## City of Sedona Public Works Department

The City of Sedona, Arizona is issuing **Addendum #2** to the plans and specifications as originally issued at the time of solicitation for bids for the re-bid of **SR 179 Pedestrian Crossing at Oak Creek**. For any bid to be considered responsible and responsive, receipt of this addendum must be acknowledged.

This Addendum further extends the bid period beyond the extension issued under Addendum 1, providing a new date for which sealed bids must be submitted; responds to questions related to the project plans and specifications; and provides for revisions made to the project specifications and drawings.

**DEMOLITION PLAN SHEET**

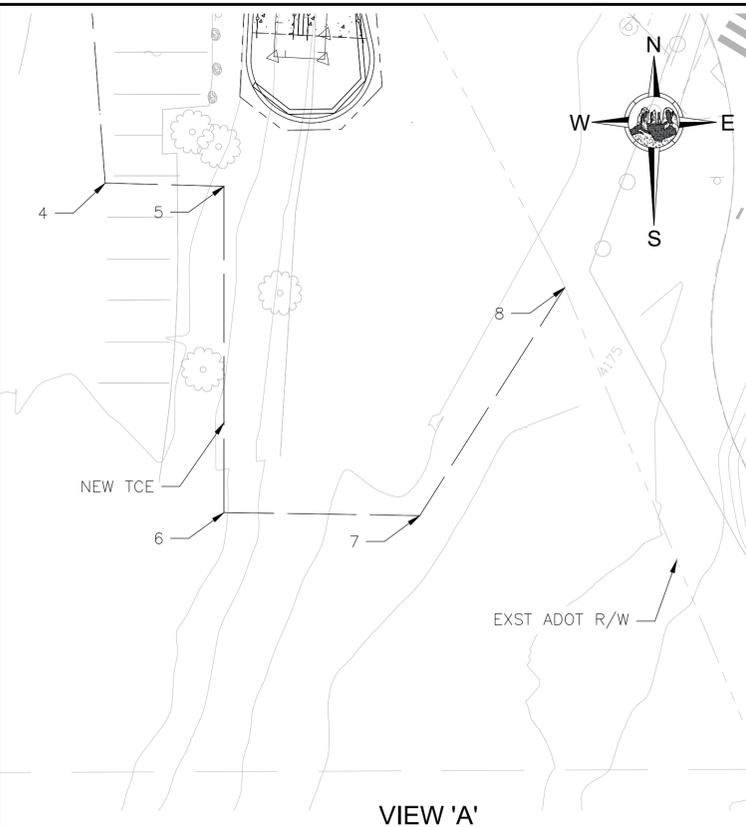
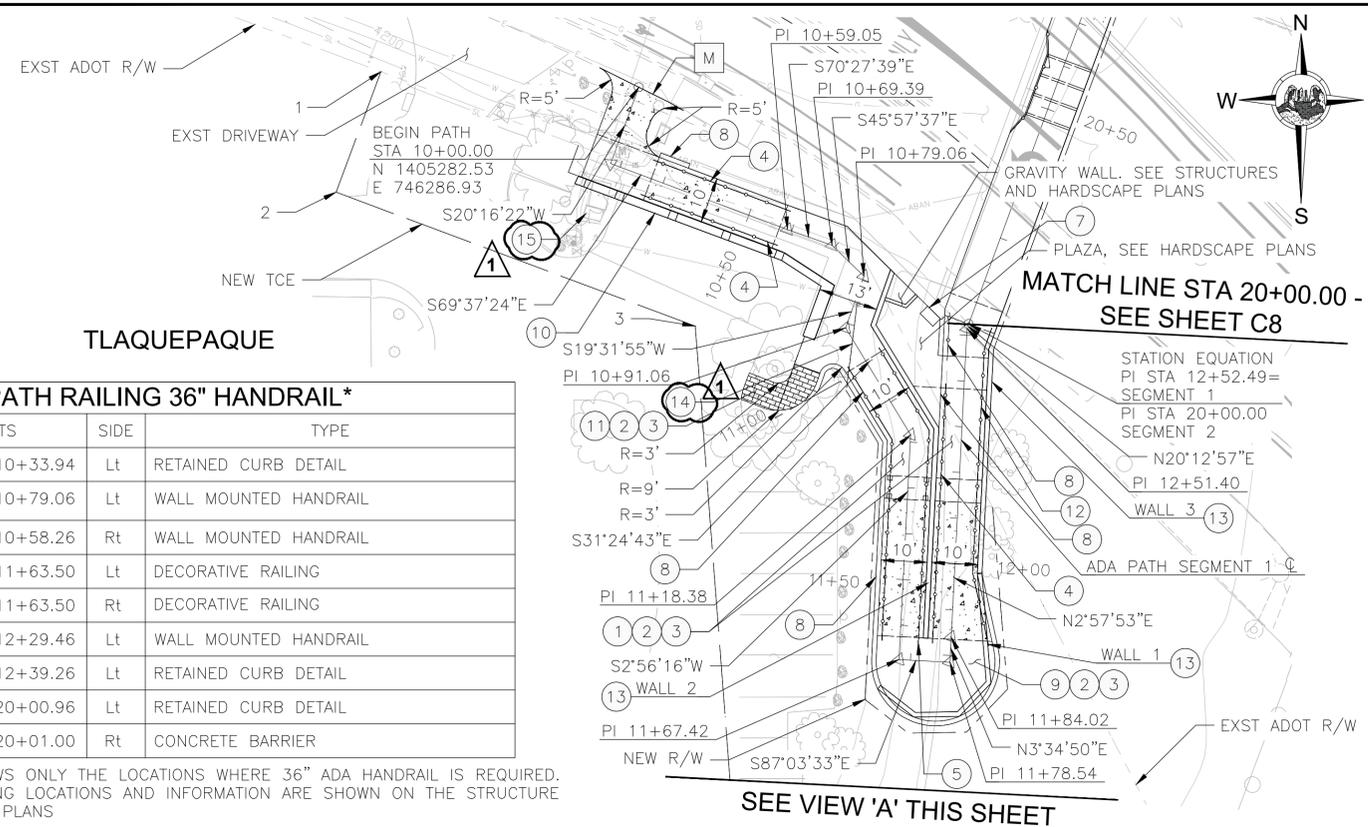
- 3.2. **Question** – On the Demolition Plan Sheet C6 there are the following construction notes with no associated bid items in the Bid Schedule; How should the contractor address these items?

- "3 - Relocate Existing Irrigation Valve Per AWC Specifications."** Item added to specification for clarification.
- "5 - Remove & Salvage Existing Decorative Boulder."** Item will be removed from Demo Plan, not applicable.
- "14 - Remove Existing 2" Blow Off Assembly and Replace With 90 Degree MJ Elbow, 6 LF of 6" DIP, and Transition Couplings."** Item added to specification for clarification.

- d. **"6 - Relocate Existing Water Valve."** Specification has been updated for consistency and clarification.
- e. **"13 - Replace & Relocate Existing 2" Water Service Connection."** Item added to specification for clarification.

3.13. **Question** – Bid Item No. 2.2.4 “Remove and Salvage Existing Property Wall” and Note 7 on C6 “Remove Exist Property Wall” are in conflict. Should “and Salvage” be removed from the bid item description?

*Removal Notes 3 and 10 were revised.*

**Response** – The Demo plan will be updated for Item Consistency with Specifications

**Response** – The CMU portions of the lower don’t need to be saved or salvaged, just the ornamental aspects of the wall, such as the wall column caps, flowerpots/containers and plants, and tile pieces making up the triangular ribbon along the top of wall.

**Revised** sheet 6 of 45 (C6) revision dated 3/3/2023, as provided in listed attachment 3.2 of this Addendum 2.
